**COBB COUNTY
DEPARTMENT OF TRANSPORTATION
ENGINEERING DIVISION**

**Florence Rd @ Hiram Rd/Gaydon Rd
Project No. B2448
May 21, 2026**

ADDENDUM NO. 1

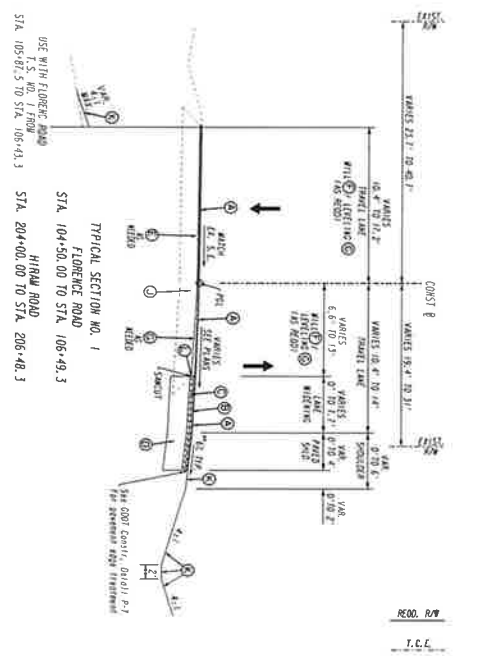
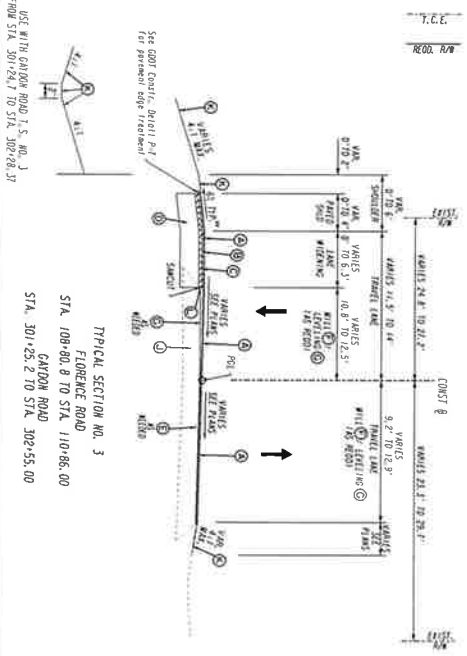
Q. The Typical Sections and Summary of Quantities show that all roads are paved with 1.5" Asph Conc 12.5mm Gp 2 and the roundabout only is paved with 1.5" Asph Conc 12.5mm Gp 2 Incl Polymer Modified BM&HL. There is only one Pay Item which is for 12.5mm Polmer Mod BM&HL. Will a Pay Item be added for 12.5mm Gp2 only and the Polmer Item quantity be adjusted or will the plans be changed to specify 12.5mm Polymer in all locations?

A. **All roads will be paved using polymer.**
